Appendix J: Public Involvement Program

From:	Karl Rudnick
To:	Clerk of the Board
Cc:	David Zito; Lesa Heebner
Subject:	Fwd: Public comment on SANDAG 2025 Regional Plan and for 7/18/2025 Transportation Cmte meeting
Date:	Thursday, July 17, 2025 8:45:49 AM
Attachments:	S Coast Hwy separated bikeway case report v0.9-DRAFT.pdf Dixon-FHWA study critique v0.9-DRAFT.pdf

S0031.B	n/a	n/a	How about flexible lanes during peak hours? A middle lane which goes one way in the morning, and the other way in the afternoon?
S0031.C	n/a	n/a	The public outreach seems to be minimal.
S0032	n/a	Caltrans	Regional Plan Overview Pg. 6, Figure 1-1 - provide definitions of Jobs Total vs Jobs Wage & Salary. Unclear on what is Jobs Wage & Salary.
S0033.A	n/a	n/a	there should be a priority on south bay rapid transit such as a RAPID route linking Otay Ranch and Palomar street, and the purple line. currently getting from near third avenue to otay ranch could take over an hour if you arent near the 709L. I believe that there could be a protected bus lane up the center of main street and H street as there is on east palomar. also, a rapid route linking otay mesa, otay ranch and El Cajon would help travel times in e

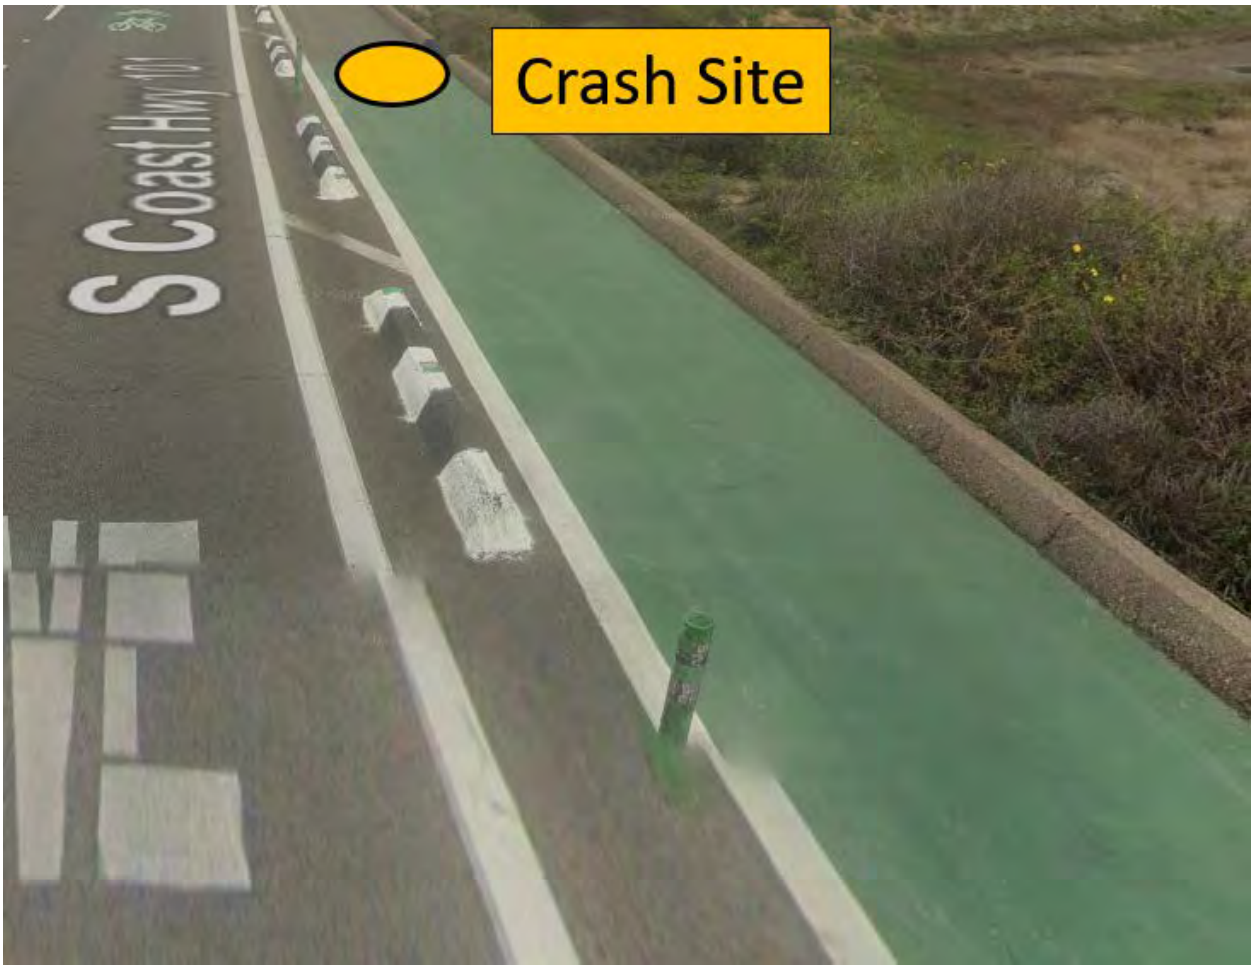
On March 17, 2024, USMC Captain “Ryan” was killed at the location shown below near the northbound entrance at the southern city limit.[10] The police report determined the cause to be a collision with a fixed object, presumably a wheel stop, a plastic post, or the curb.[12]

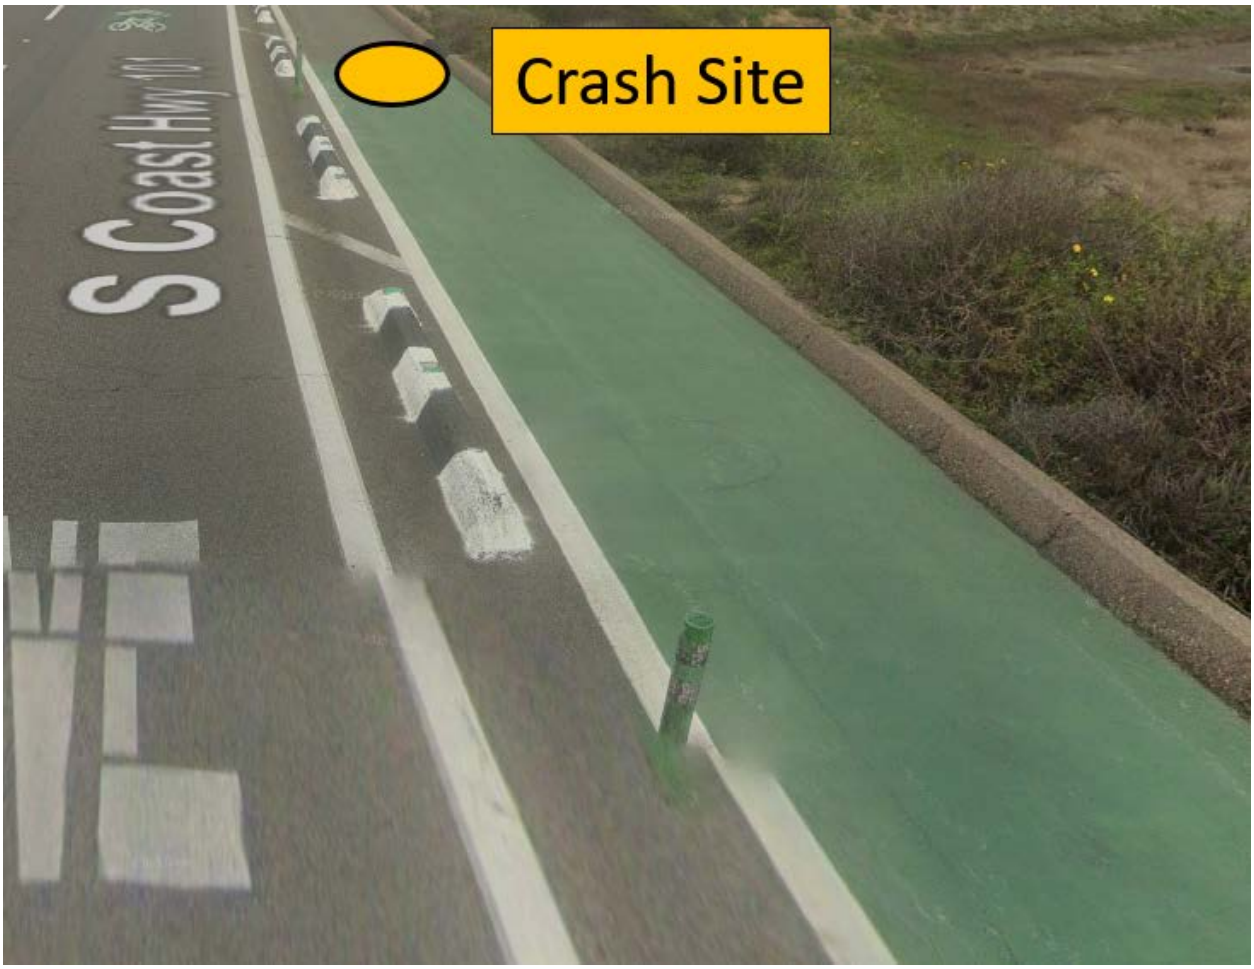
On March 17, 2024, USMC Captain “Ryan” was killed at the location shown below near the northbound entrance at the southern city limit.[10] The police report determined the cause to be a collision with a fixed object, presumably a wheel stop, a plastic post, or the curb.[12]

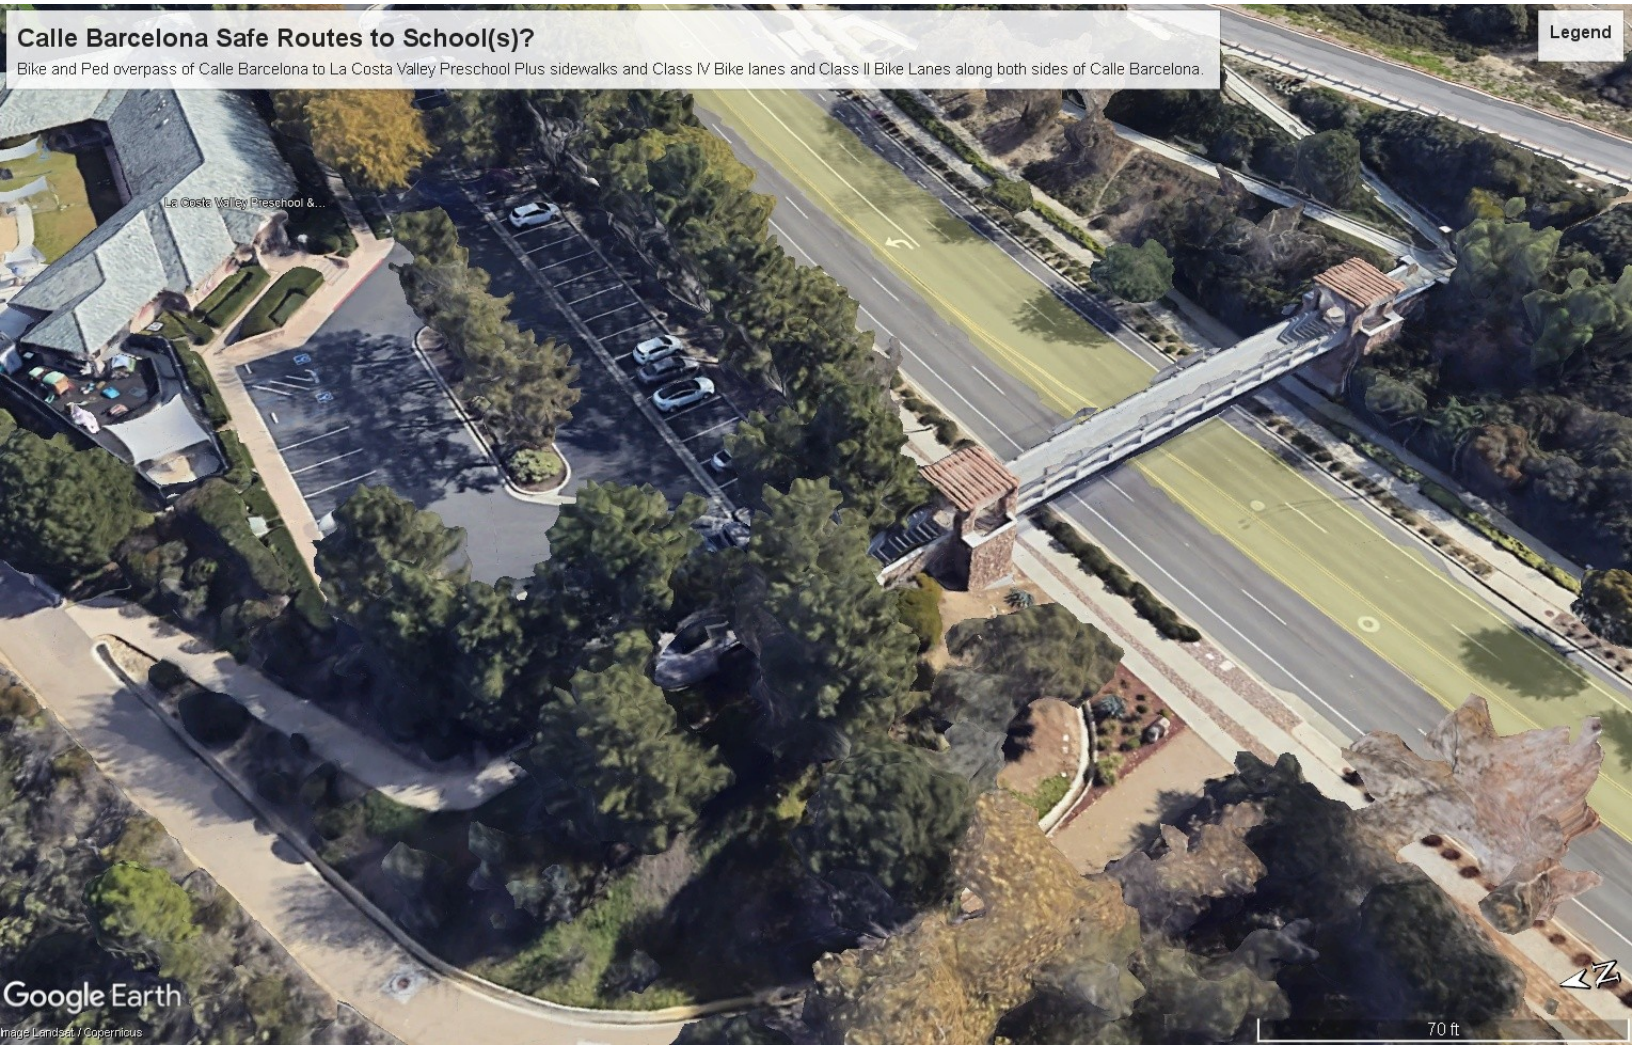
Calle Barcelona at Paseo Aliso
Class I at intersections and Class IV with adjacent sidewalks between plus Class II Bike Lanes along Calle Barcelona from El Camino Real to RSF (?)
Legend
Paseo Aliso
Paseo Aliso
Google Earth
Image Landsat / Copernicus
Data SIO, NOAA, U.S. Navy, NGA, GEBCO
60 ft
